Aqueous Solutions (owner) AQS-MFG-TI_CELL-NOZZLE_ORIENT
TI_CELL fabrication drawing NOZZLE_ORIENT (AQS-PLAN-006 M3;
Type: fabrication drawing (GA / nozzle orientation / part sheet) Rev d636df68 Issued 2
Created: flow graph pipeline Approved: not approved (study)
Sheet 1 of 1 AQS-DWG-001

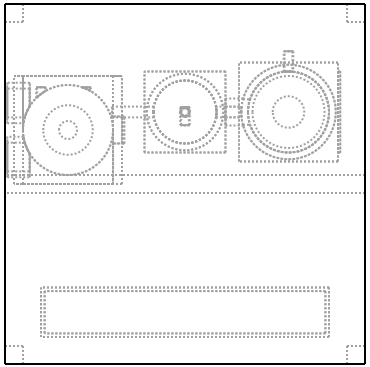
Graph revision AD - nozzle_orient: N2/N10/N11 charge chutes -X z 160 on the chlorinator (grit, rutile concentrate, carbon reductant)
Graph revision AD - nozzle_orient: N3/N9 Cl2 stubs -Y z 160 on the chlorinator (loop with MG_POT)
Graph revision AD - nozzle_orient: N12 CO export +Y z 600 and N1 slag spout +Y z 600 on the chlorinator
Graph revision AD - nozzle_orient: N4/N5 harvest ports +X z 600 and N8 Mg chute -X z 160 on the reduction retort
Graph revision AD - nozzle_orient: N6/N7 MgCl2 stubs +Y z 600 on the retort (return to MG_POT; drag-out to flux)
Graph revision AD - nozzle_orient: N13 drain bottom (170,560); N14 vent on the condenser top riser at z 800
Graph revision AD - nozzle_orient: Heights/bore/rating per docs-authority/nozzles/TI_CELL.csv; compass faces are the registered layout. Three diagrams isolate
